Report Committee of Adjustment

File: A-2023-0113

Address: 18 Scarlett Drive

ALTERATIONS (DRIVEWAY)

SITE PLAN - PROPOSED

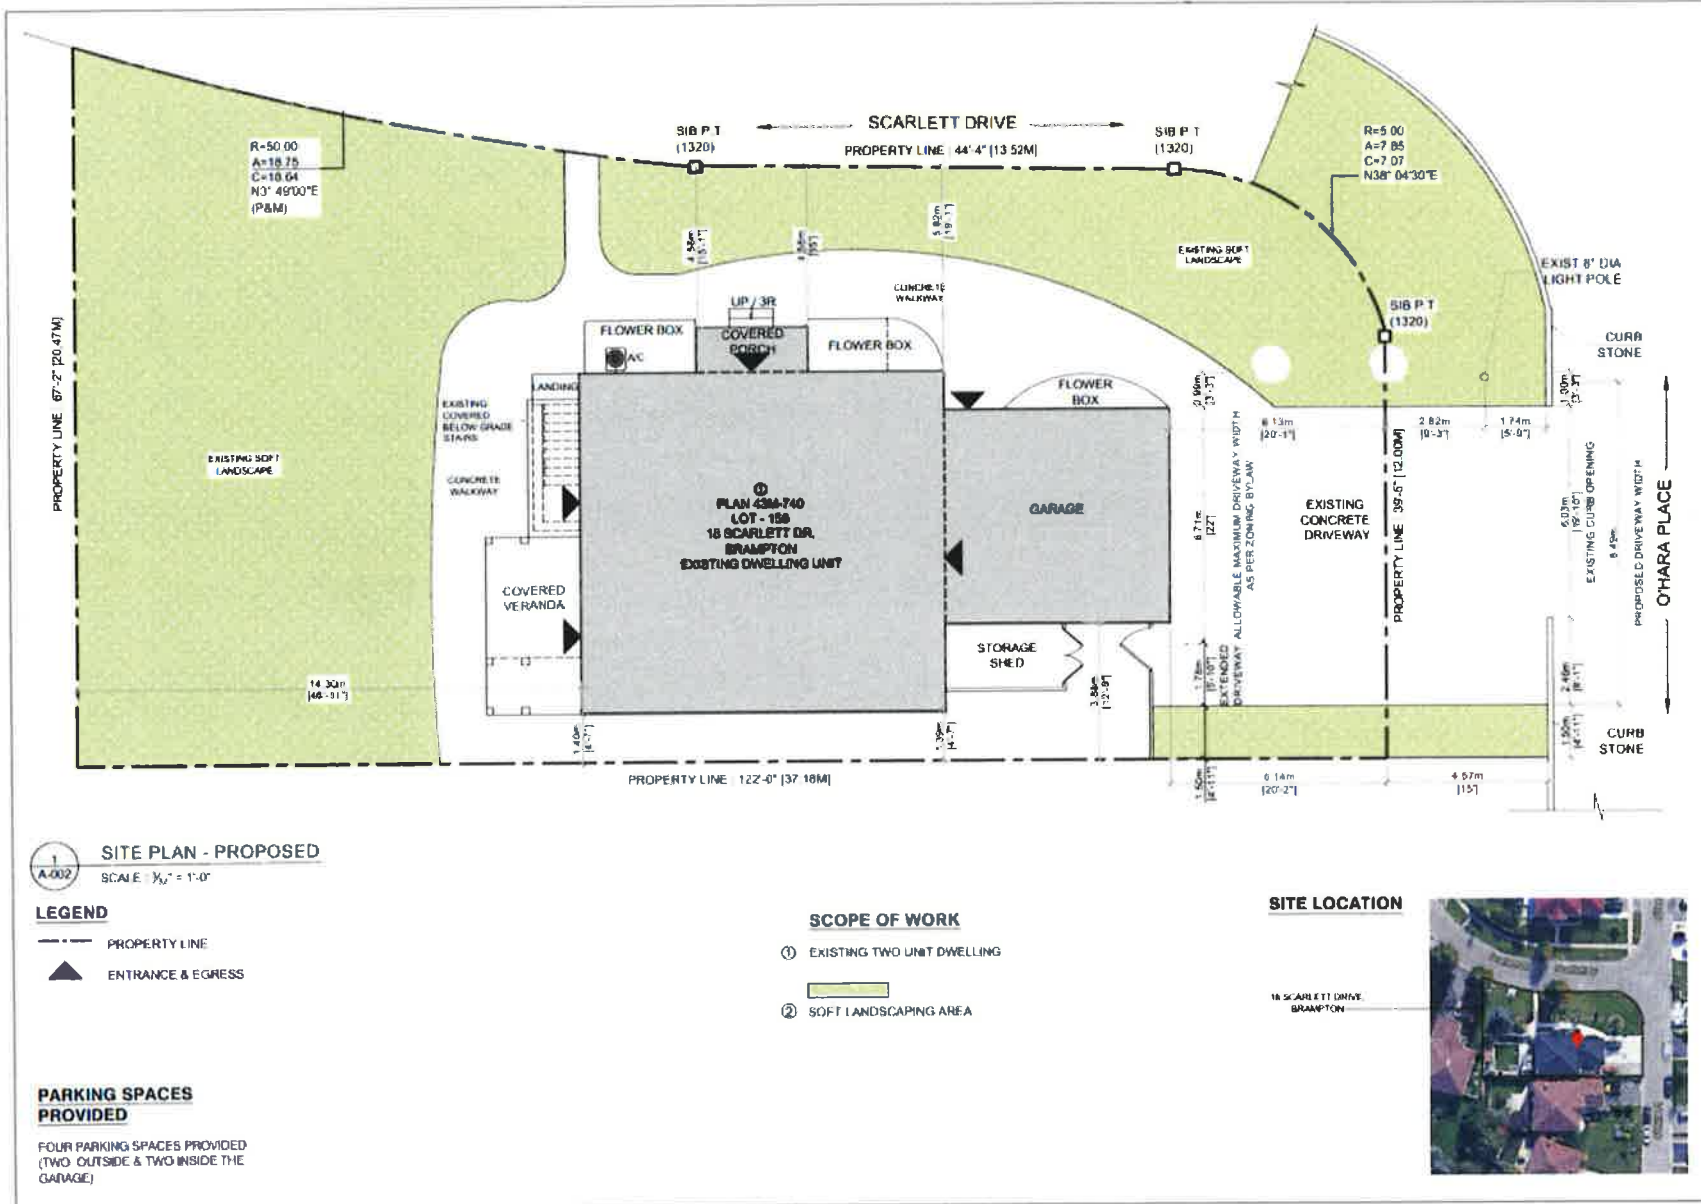
1. That the extent of the variance be limited to that shown on the sketch attached to the Notice of Decision;
2. That Variance 1 to permit a driveway width of 9.18m (30 ft.) whereas the by-law permits a maximum driveway width of 7.32m (24 ft.) be refused. Staff recommend that approval be based on the revised site plan provided by the applicant (Appendix B) showcasing a proposed 8.49m (27.85 ft.) driveway width;

4. The Owner is to remove the "as-built planter box" from the City's right-of-way;
5. The Owner is to reinstate the driveway in accordance with the revised site plan (Appendix B), depicting the original width and distance from the City's existing light pole as well as removing the as-built interlock pavers;

Note: a revised site plan (Appendix B) has been submitted which depicts a reduced driveway width equating to 8.49m (27.85 ft.). Therefore, the requested variance is amended to permit a driveway width of 8.49m (27.85 ft.) whereas the by-law permits a maximum driveway width of 7.32m (24ft.).

Staff recommend that the requested variance for a 9.18m (30 ft.) driveway width be refused, and that approval be based on the revised site plan provided by the applicant (Appendix B) showcasing a driveway width of 8.49m (27.85 ft.). As per the review of the revised site plan provided by the applicant (Appendix B), the existing driveway width is proposed to be reduced by adding permeable landscaping on both sides of the driveway. The revised driveway width would be 1.17m (3.84 ft.) wider than what the by-law permits. The western portion of the driveway was installed as a decorative extension (interlock pavers) to the existing driveway. As per the site visit (Appendix A), it appeared that the driveway extension was not used for the parking of vehicles but rather functioned as a dedicated walkway to the rear yard. Staff are of the opinion that the revised configuration of the driveway and restoration of permeable landscaping reduces the amount of hardscaping on site and does not allow an excessive number of cars to be parked in front of the dwelling. In addition to the property being located on a corner lot and the applicant reinstating landscaping, sufficient front yard landscaping area is maintained, and an unobstructed path of travel to the main entrance is provided. Therefore, Staff recommend that the variance be refused, and that approval be based on the revised site plan provided by the applicant (Appendix B) showcasing a proposed 8.49m (27.85 ft.) driveway width.
